UNITED STATES PATENT AND TRADEMARK OFFICE

10/596,829

Office Action Summary	Application No. 10/596,829	Applicant(s) SCHMIDT ET AL.	
	Examiner ANATOLY VORTMAN	Art Unit 2835

DETAILED ACTION

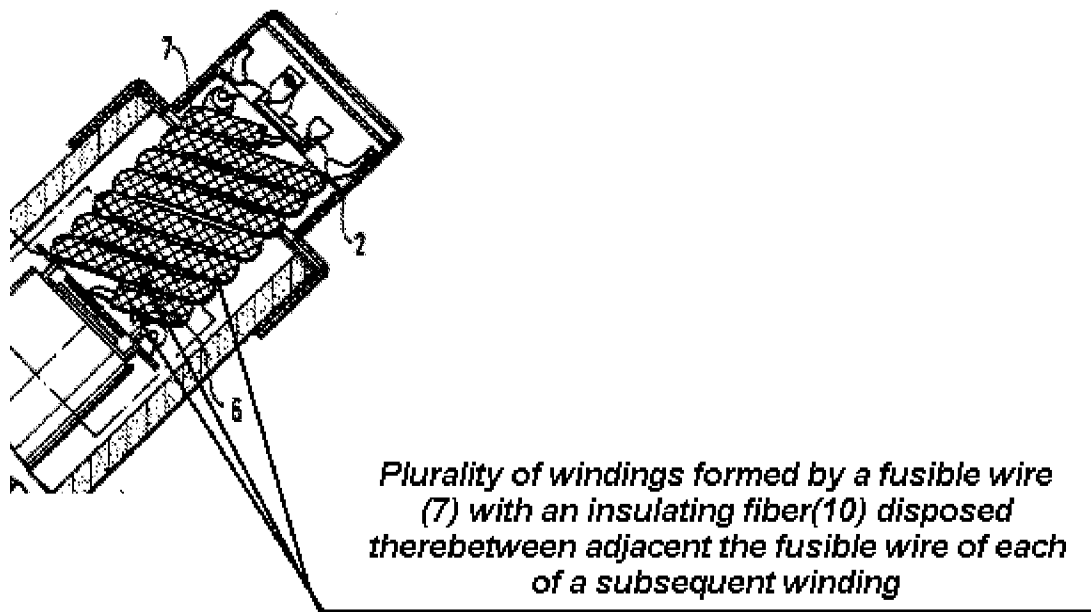
5. Claim 12, as best understood, is rejected under 35 U.S.C. 102(b) as being anticipated by US/4,523,172 to Drothen et al. (Drothen).

Regarding claim 12, as best understood, Drothen disclosed (Fig. 2-3) a fusible conductor for a fuse element, said fusible conductor comprising: an electrically insulating core (6); a fusible wire (7) wound about and in contact (at least thermal) with the core (6) forming as a plurality of

first windings; and an electrically insulating fiber (10, 11) wound about the core forming a plurality of the second windings and disposed between each of said plurality of the first windings such that the insulating fiber is adjacent a fusible wire of a subsequent winding (see annotated figure below):

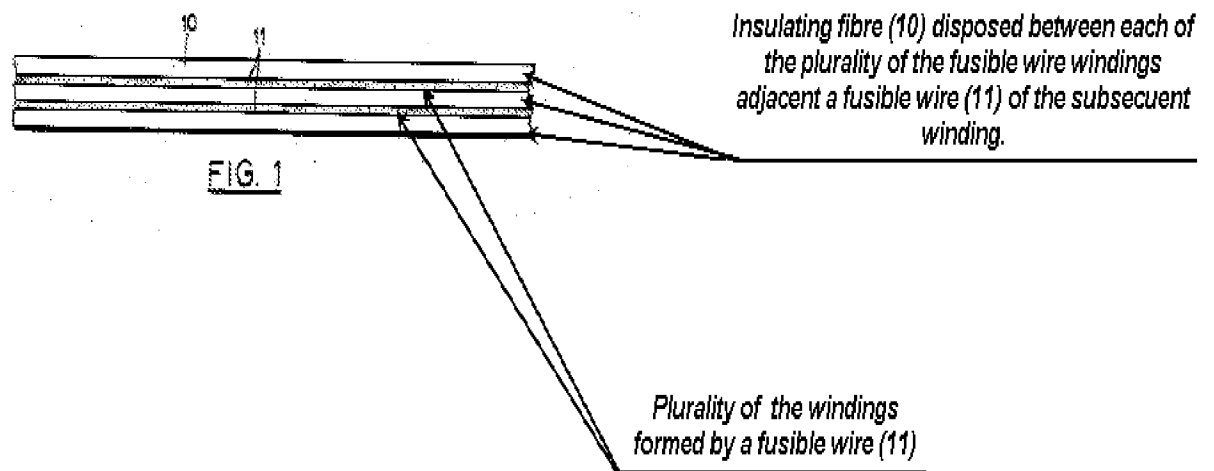
6. Alternatively, claim 12, as best understood, is rejected under 35 U.S.C. 102(b) as being anticipated by US/ 3,486,155 to MCCAUGHNA.

Regarding claim 12, MCCAUGHNA disclosed (Fig. 1, 2) disclosed (Fig. 2-3) a fusible conductor for a fuse element, said fusible conductor comprising: an electrically insulating core (12); a fusible wire (11) wound about and in contact (at least thermal) with the core (12) forming a plurality of first windings; and an electrically insulating fiber (10) wound about the core forming a plurality of second windings and disposed between each of said plurality of the first

windings such that the insulating fiber of each of the second winding is adjacent a surface of the fusible wire of a subsequent one of the first windings (see annotated figure below):
